ADDENDUM #1

**BID NUMBER: 23-16
ELECTRONIC DOOR ACCESS CONTROL SYSTEM**

Argosy – First Floor

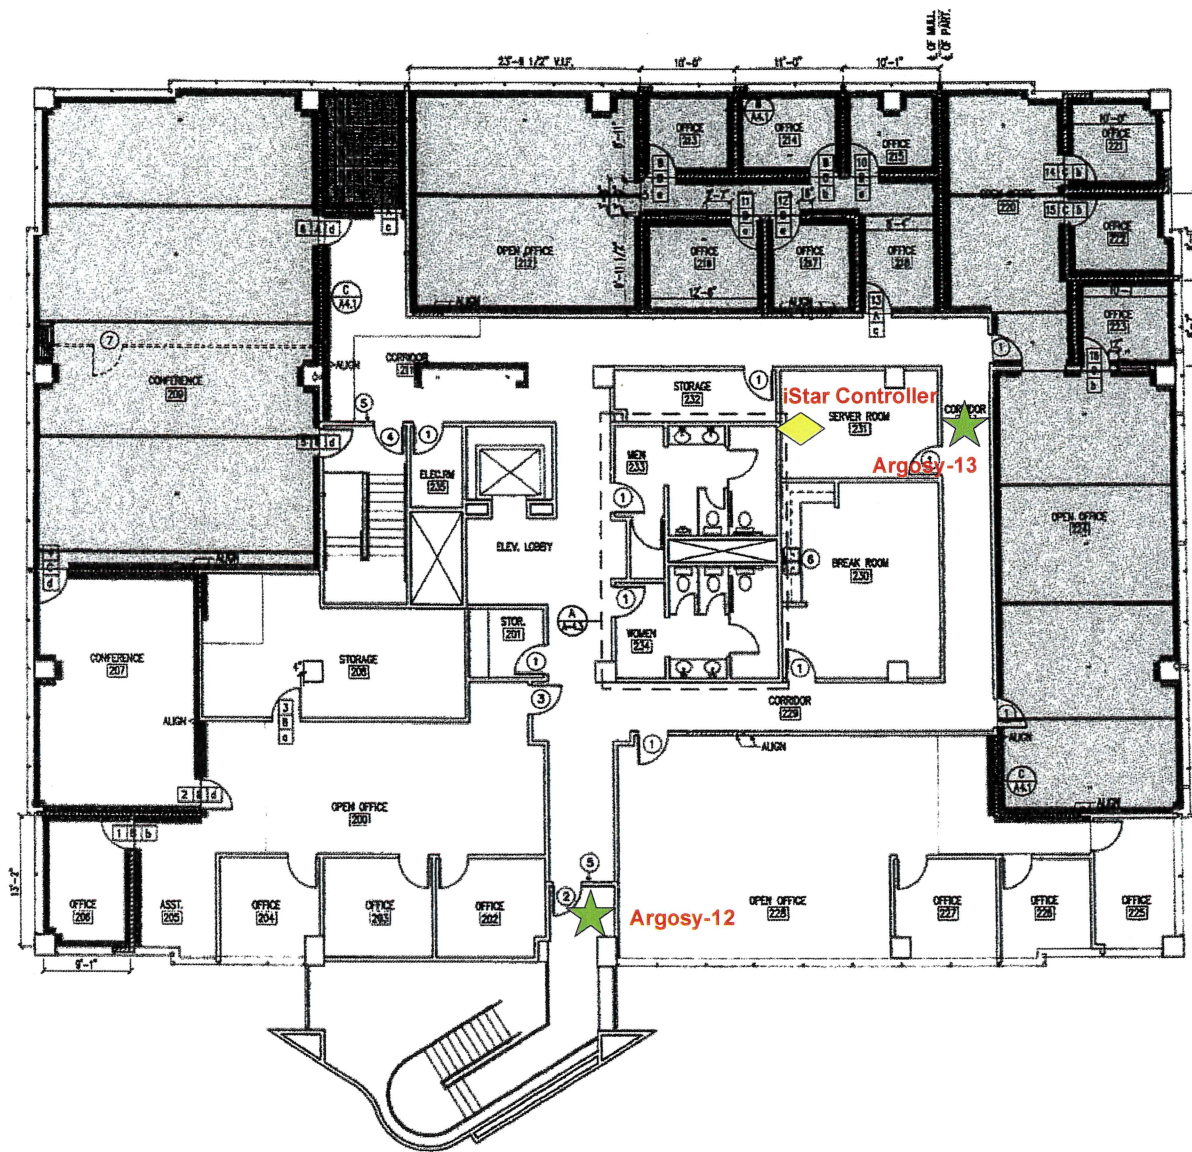
2. Pages 43 - 45 Argosy - First, Second and Third Floor Diagrams. Please replace with the attached revised diagrams for the Argosy – First, Second, and Third floors.
